SECTION 4 RESPONSES TO COMMENTS ON DRAFT REIR (DECEMBER 2004)

For those portions of the Draft REIR for the September Ranch Subdivision Project SCH No. 1995083033 (December 2004) that have been superseded by the Recirculated Portion of the Draft REIR for the September Ranch Subdivision Project SCH No. 199508033 (February 2006) this section refers to the "Recirculated DREIR" All other portions are cites as "Draft REIR."

Exhibit 4.9-1 Vegetation Map

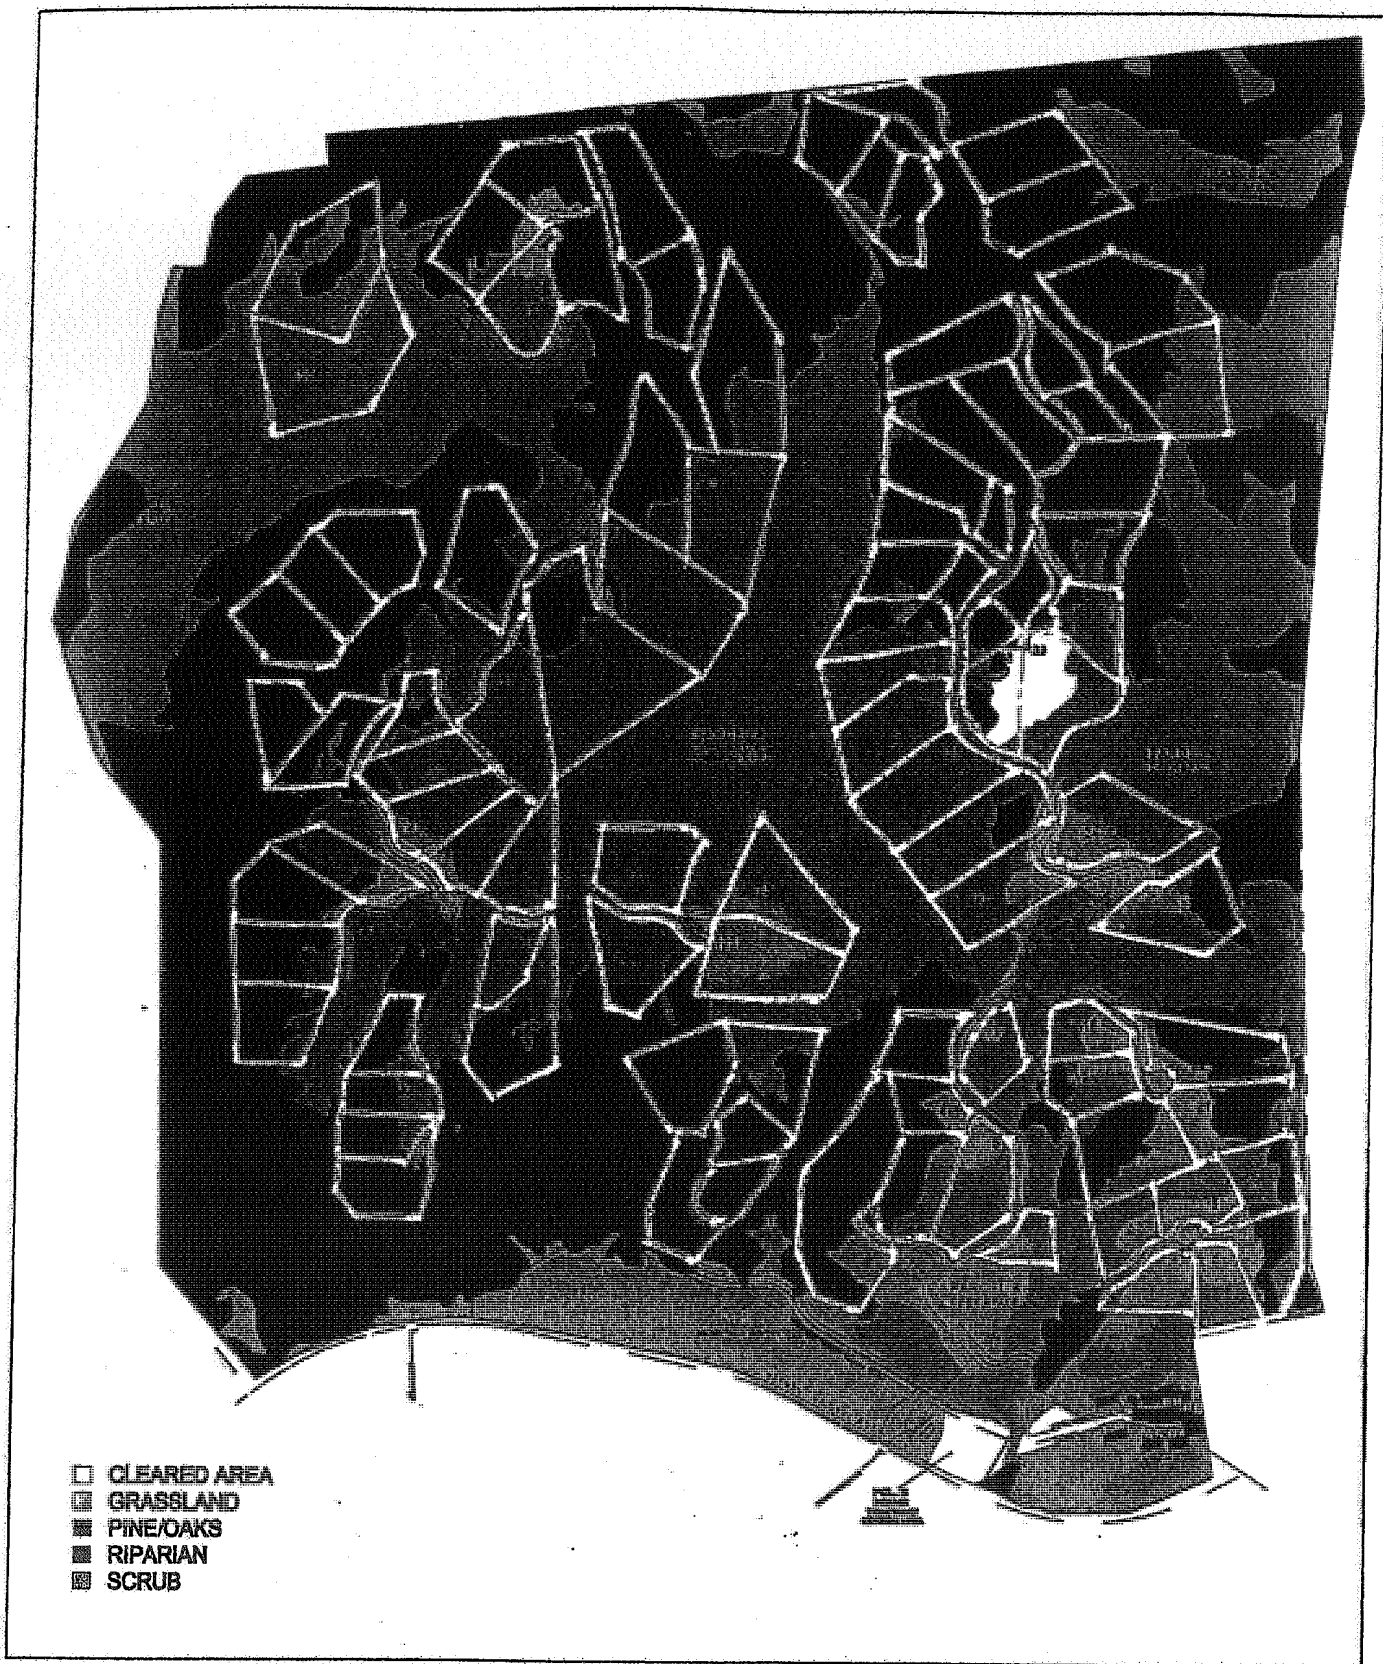
Exhibit 4.9-1 and Table 4.9-1 do not distinguish between native grasslands and non-native grasslands. This distinction may have significant siting and biological implications. Please correct the exhibit to show this.

16) The DREIR fails to address the fragmentation of Monterey pine forest. While the direct loss of trees is discussed, the effect of development in and among the forest has not been addressed. Exhibit 4.9-1 of the DREIR is a vegetation map which shows lots scattered throughout the pine and oak forest. Moreover, as the DREIR states on p. 4.9-6, the Monterey Pine/Mixed Oak Woodland contains important understory plants that provide seasonal food

The project site will retain 782.8 acres of the 891-acre project site as open space. As shown on Exhibit 4.9-1, Vegetation Map of the Draft REIR the open space area contains a variety of habitat communities. As discussed in Response to SOCR 1-118, several factors were considered in the design of the proposed lot configuration, including but not limited to topography and slopes, accessibility, aesthetics, and biological sensitivity.

Exhibit 3-3
Site Plan

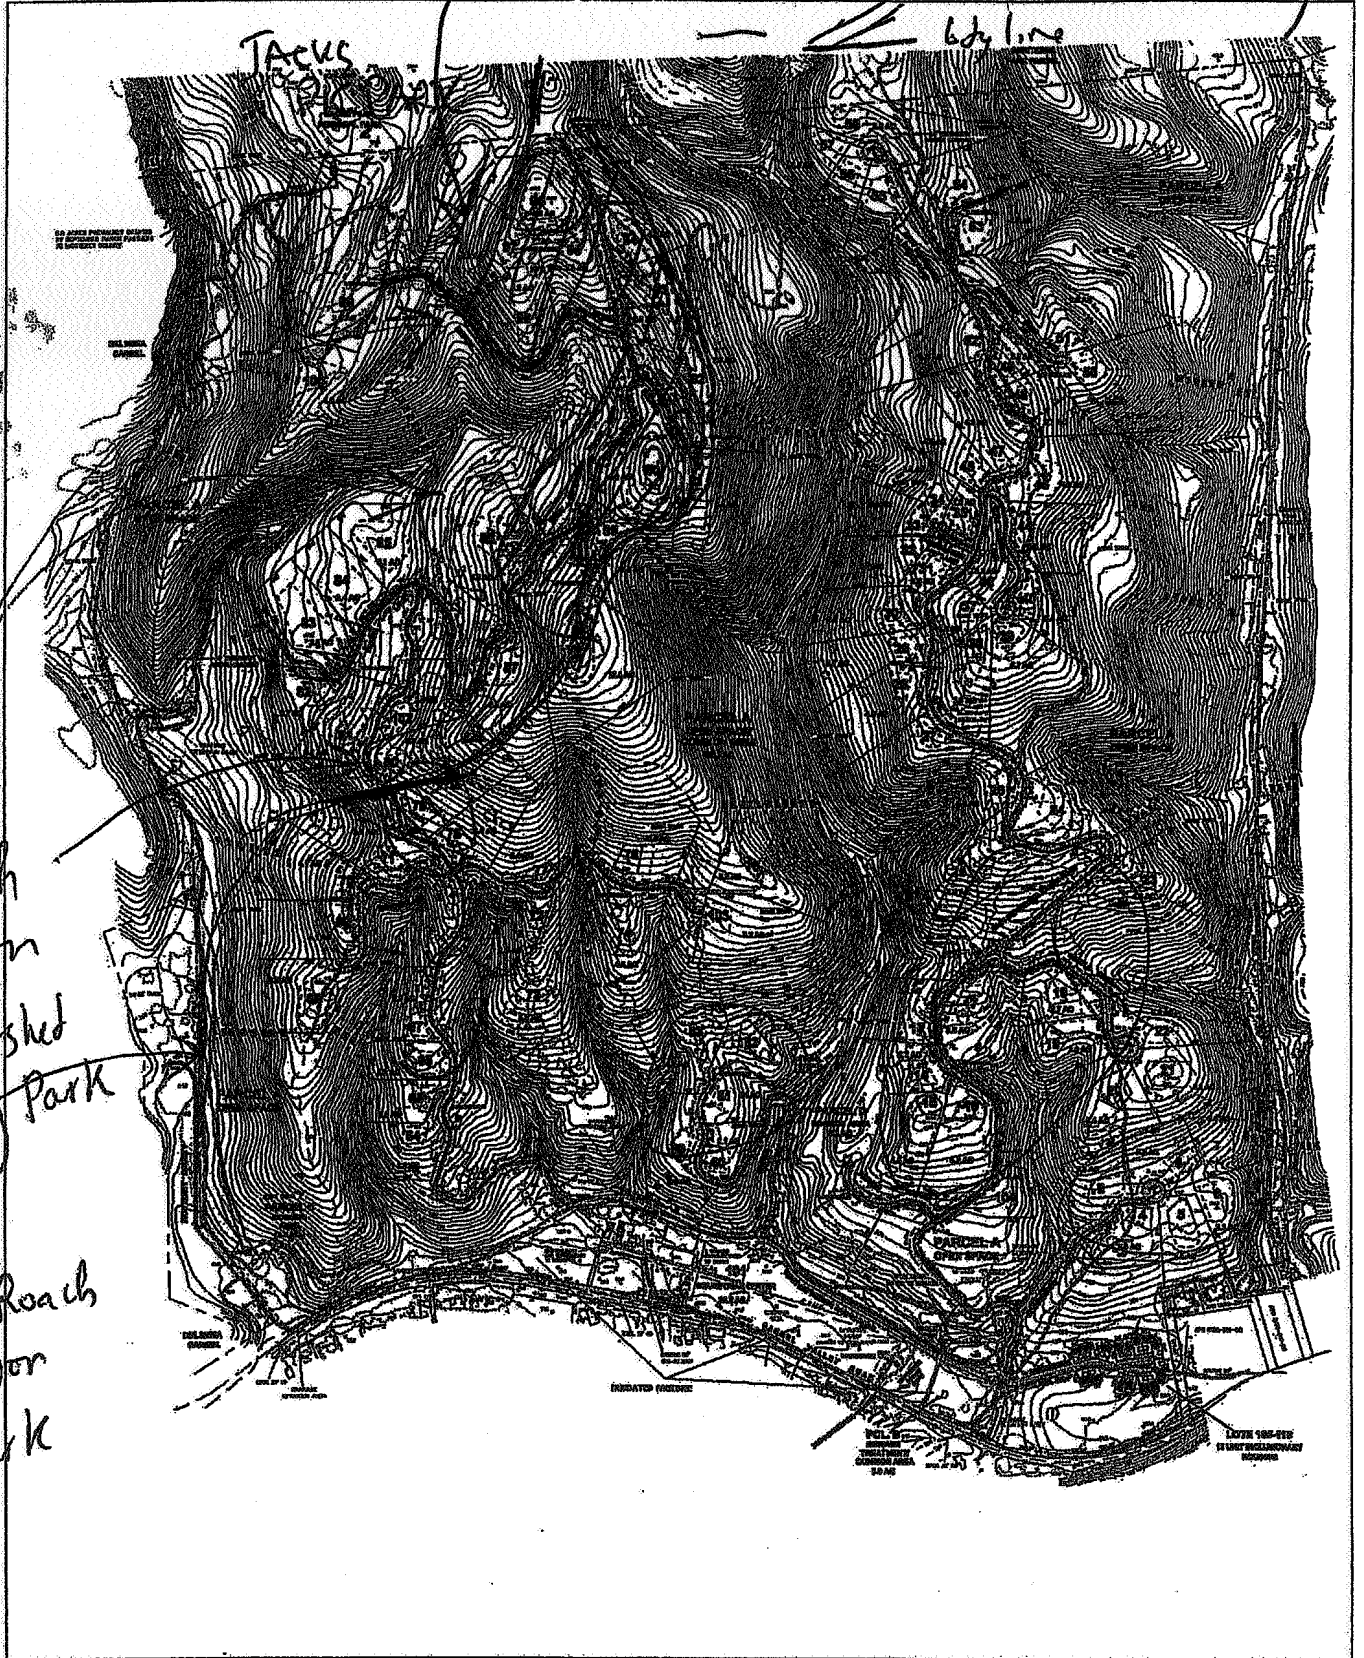
Exhibit 3-3, the "Site Plan," does not clearly show the proposed access, building envelopes, or many other critical plan components. The DREIR should provide a large map with all these missing components, and recirculate the DREIR for comments. The public cannot comment effectively or in an informed manner without that information.

Page 4.1-8. The location of the 15-unit inclusionary housing is described as being on the southwest corner of the site. The Site Plan (Exhibit 3-3) depicts the location as the southeast corner of the project property. Please clarify.

2.2 and Exhibit 3-3: Paragraph 2.2 says that "the projects development on the 891-acre project site is situated in the southern portion of the property;" but the Site Plan, Exhibit 3-3, clearly shows that what are described as Phases 3 and 4 in paragraph 3.2 are located in the northern portion of the property. Examination of the Site Plan, Exhibit 3-3, shows that in fact about one-half of the development is located in the eastern portion of the property and extends from the north boundary to the south boundary; and that in fact about one-half of the development is located in the western portion of the property and extends from the north boundary to the south boundary.

2.1,3.2 and Exhibit 3-3: These citations are not consistent in the use of the terms "common open space," "Open Space," and "open space common area." 2.1 uses the term "common open space," 3.2 uses the term "Open Space," and the Site Plan, Exhibit 3-3, uses the term "open space common area." While open space may be dedicated to that purpose in perpetuity, common area could subsequently be used by a homeowners' association for the construction of common facilities. The proposed uses and limitations as to these areas must be clarified and determined.

As discussed on page 3-1A of the Draft REIR, and Section 4.6, Transportation and Traffic and as shown on Exhibit 3-3 Site Plan of the Draft REIR, site access is going to be provided opposite the intersection of Carmel Valley Road and Brookdale Drive.

The Site Plan identifies the parcels rather than the building envelopes; however, as indicated in the Draft REIR, impacts were analyzed based upon building envelopes. Specifically, as stated on page 4.9-1 of the Draft EIR, for purposes of the biological assessment and subsequently the EIR analysis, it was assumed that habitat values within the building envelopes of each lot will be lost as a result of project buildout. Exhibit 4.9-1 identifies the native plant communities/habitat types located onsite as well as the residential lots and Table 4.9-2 identifies the impacted vegetation communities. Therefore, the Draft REIR provides an adequate level of information in regards to impacts within the building envelopes (the building envelope is presumed to be approximately 0.33 acres for each of the parcel sites for the purpose of this analysis).

As shown on Exhibit 3-3, Site Plan, Parcel C is Common Area, which is distinguished from Parcel A, which is Open Space.

The inclusionary housing is to be located in the southeastern portion of the project site as identified on Exhibit 3-3. The first sentence of the second paragraph on page 4.1-8 of the Draft REIR is revised as follows:
